**Hunter F. Mk. 6 Aircraft—Rotol Mod. No. GB.1109 (Introduction of Centrifugal Breather) Catered for (Mod. No. Hunter/751.)**  
 (Class B/2 on fitment of modified gearbox.)  
 (AB/A/8189. 17.8.59.)

## 1. INTRODUCTION

DRG. No. A.P. 4347F/SI/59.

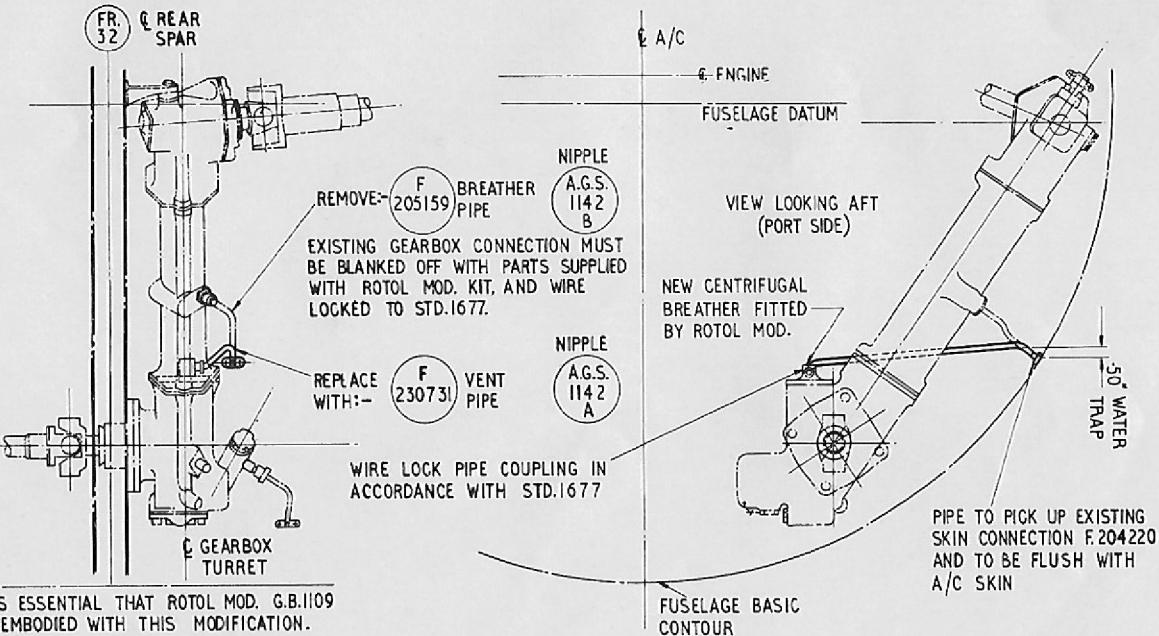
To prevent loss of oil, with consequent damage to the Gearbox Turret drive arm, Rotol Mod. G.B. 1109 (Introduction of Centrifugal breather) has been introduced. This necessitates repositioning the breather pipe on the Gearbox Turret drive arm.

- (1) Remove the gearbox turret access door.
- (2) Remove the Breather Pipe, Part No. F.205159, together with Nipple, Part No. AGS.1142/B, from the drive arm of the accessory gearbox drive assembly, as shown on the Drawing.
- (3) Fit Vent Pipe, Part No. F.230731, together with Nipple, Part No. AGS.1142/A, as shown on the Drawing.

*Note:—*Pipe connection must be locked with 22 s.w.g. stainless steel wire, Specn. D.T.D.189.
